MATANUSKA-SUSITNA BOROUGH

PLATTING BOARD AGENDA **ASSEMBLY CHAMBERS** **350 E DAHLIA AVENUE PALMER**

PLATTING BOARD MEETING **1:00 P.M.** **October 15, 2026**

CONCLUSION: The preliminary plat of Aileron Acres is consistent with AS 29.40.070 Platting Regulations and MSB 43.15.016 Preliminary Plats. There were no objections from any federal or state agencies, Borough departments, or utilities. There were no objections to the plat from the public in response to the Notice of Public Hearing. Legal and physical access will exist to the proposed lots, consistent with MSB 43.20.100 Access Required, MSB 43.20.120 Legal Access and MSB 43.20.140 Physical Access. Frontage for the subdivision will exist, pursuant to MSB 43.20.320 Frontage. A soils report was submitted, pursuant to MSB 43.20.218(A)(1).

SHEET NO. C1.1	
PRELIMINARY DRAINAGE PLAN	
JOB NO. 20260047	DATE 12 MAY 2026
DRAWN LIC	REVIEWED SRP
STEPPERS CONSTRUCTION, INC. ASPEN SANDERS 6382 E BEECHCRAFT ROAD WASILLA, AK 99645 (907) 982 0375 aspen@steppersak.com

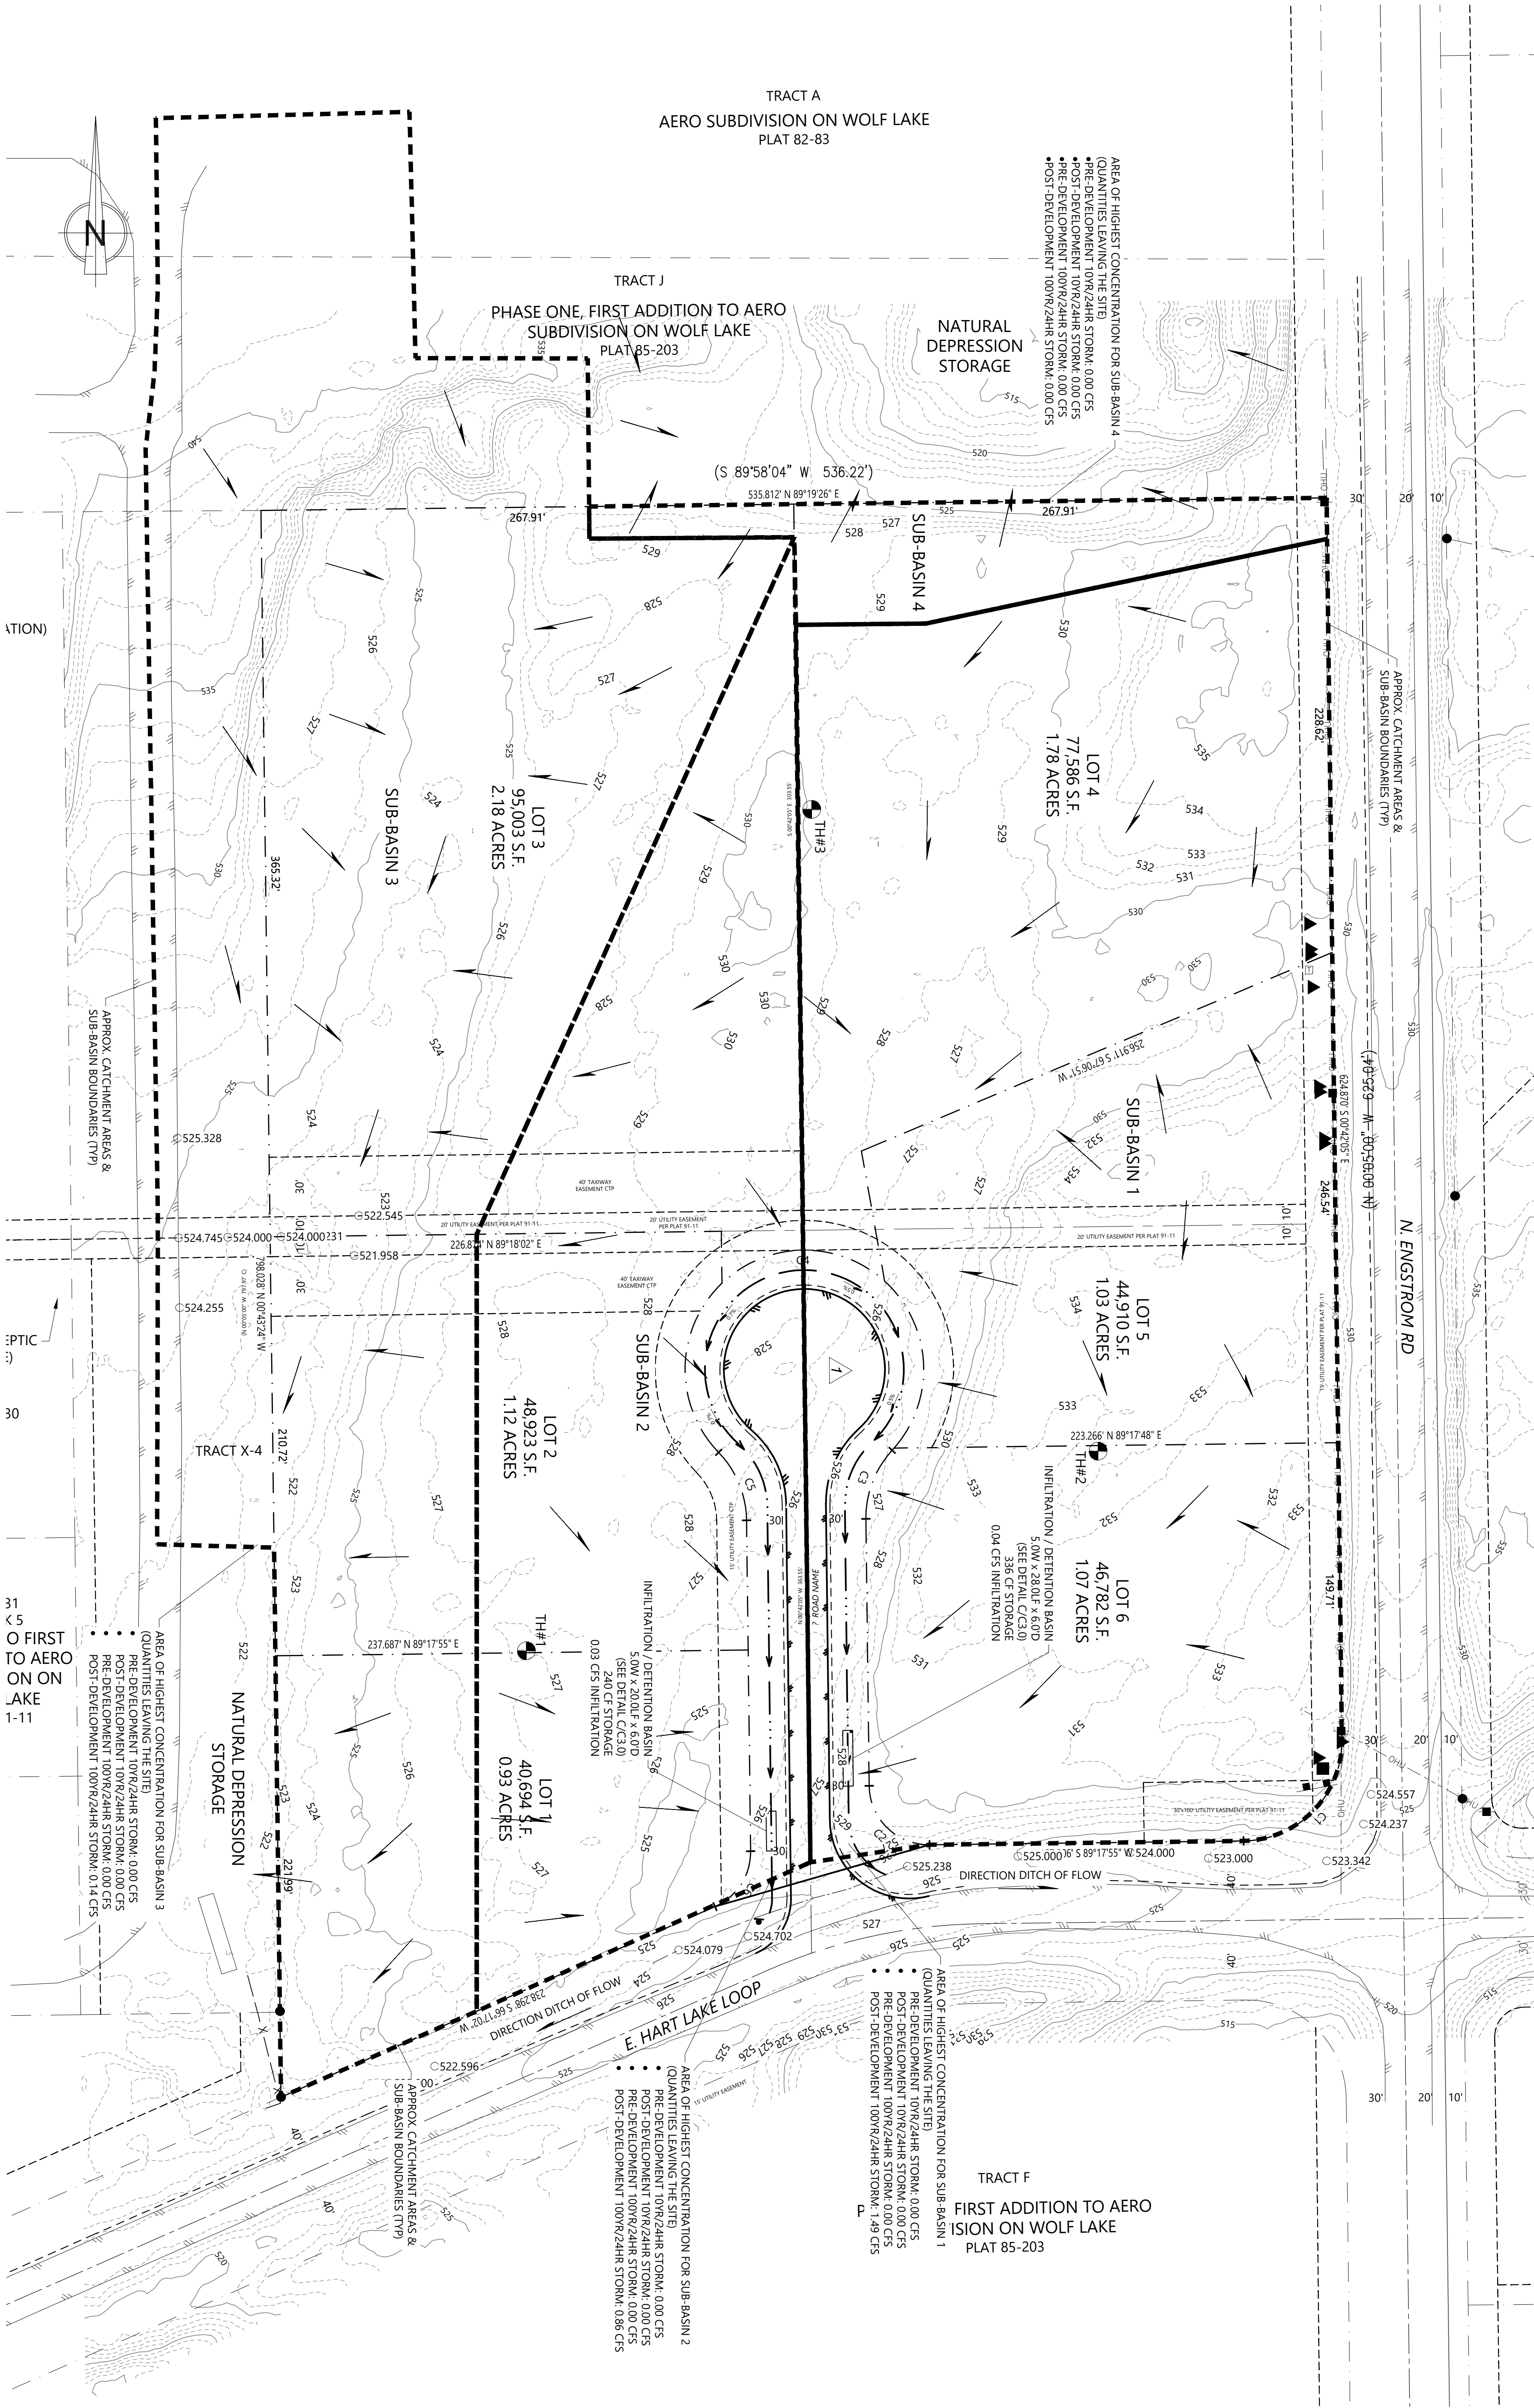
Thank you for the revised documents. Please note that PD&E will still require a cross culvert. The developer's engineer shall determine the best location and show it on the drainage plan with the drainage report. PD&E has no further comments.

SHEET NAME
SIGHT DISTANCE
DETAILS

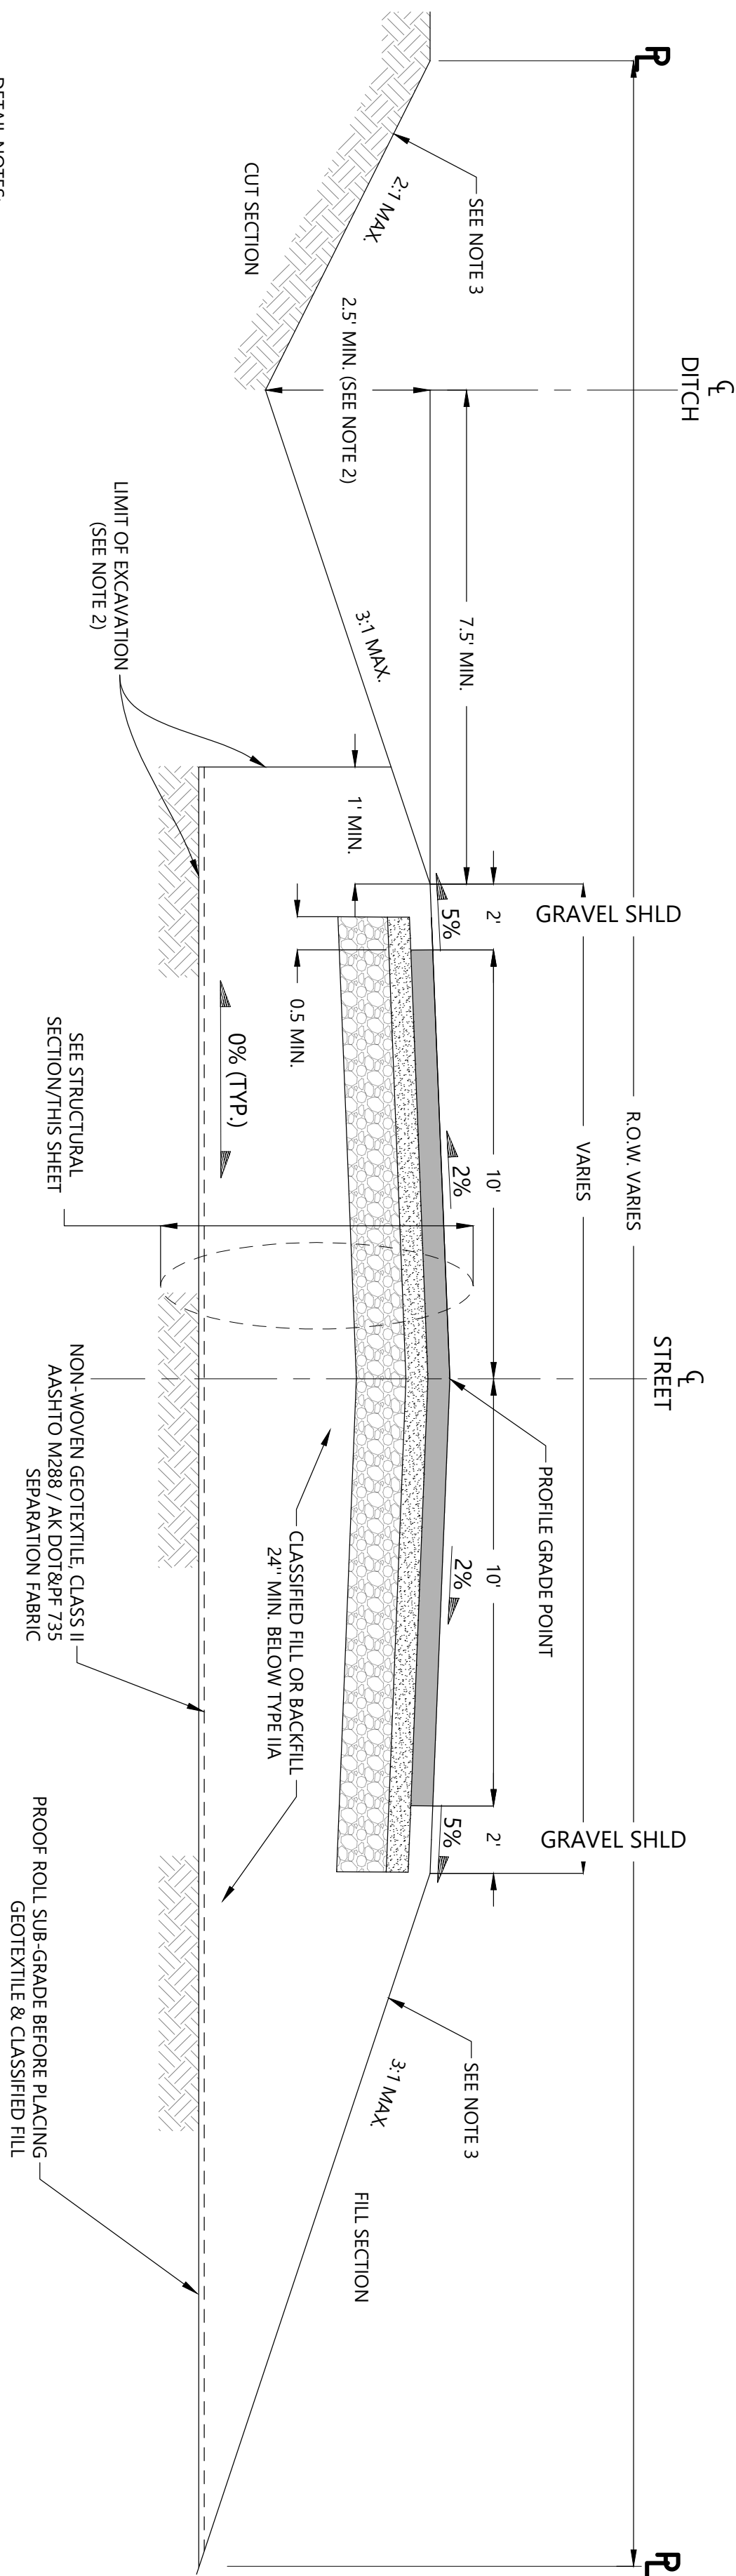
PD&E will require a cross culvert under the proposed road, location to be determined later. Sheet C2.0 shows the available sight distance; however, the end points of the sight distance triangles are not located in the center of the approaching lane. Please revise.

Please show how the minimum intersection angle of 70° is met per 2022 Subdivision Construction Manual A09.3.
